Access Compliance Report

Public Rights-of-Way

Intersection ID: N/A	Main Street: BLYTHNE_BV	Cross Street: N/A	Location: SE
ADA ID: 896EAAD0C8E7	Ramp Type: Perp	Initial Pass/Fail: Fail	Overall Compliance: No
		Severity Score: 50

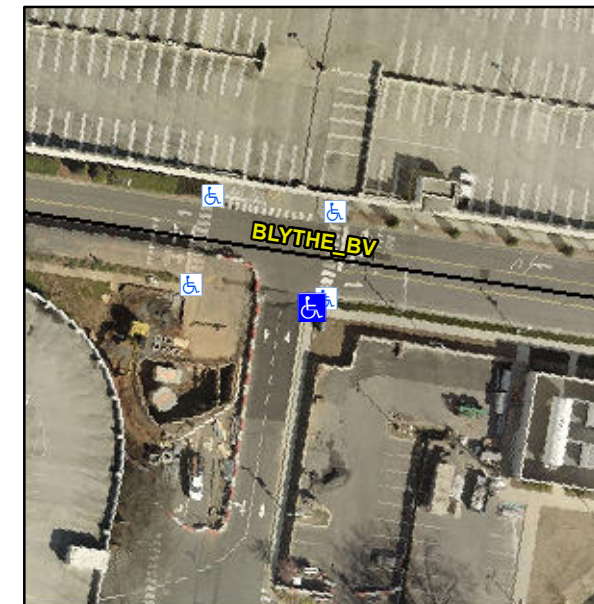
Not Found, R304.2.2, R304.5.3

Compliance	Description	Data	Compliance	Description	Data
N/A	Ramp Length (in)	55.0	No	Ramp Slope (%)	12.3
Yes	Ramp Width (in)	48.0	No	Ramp XSlope (%)	7.5
N/A	Flare Type LT	N/A	N/A	Flare Type RT	N/A
N/A	Flare Slope LT (%)	N/A	N/A	Flare Slope RT (%)	N/A
N/A	Flare Traversable LT?	N/A	N/A	Flare Traversable RT?	N/A
N/A	Landing Length (in)	N/A	N/A	DWS Provided?	N/A
N/A	Landing Width (in)	N/A	N/A	DWS Contrast?	N/A
N/A	Landing Slope (%)	N/A	N/A	DWS Length (in)	N/A
N/A	Landing X Slope (%)	N/A	N/A	DWS Full Width?	N/A
N/A	Landing Curb? (Y/N)	N/A	N/A	DWS Offset (in)	N/A
N/A	Shared Landing?	N/A			
N/A	Gutter Ponding?	N/A	N/A	Gutter Slope (%)	N/A
N/A	Gutter Lip Ht (in)	N/A	N/A	Gutter X Slope (%)	N/A
N/A	Painted X Walk1?	Yes	N/A	Painted X Walk2?	N/A
	X Walk 1 Direction	To NW		X Walk 2 Direction	N/A
N/A	X Walk 1 Width (in)	64.0	N/A	X Walk 2 Width (in)	N/A
	X Walk 1 Slope (%)	0.8		X Walk 2 Slope (%)	N/A
	X Walk 1 X Slope (%)	4.0		X Walk 2 X Slope (%)	N/A

Remove & Replace Entire Ramp.
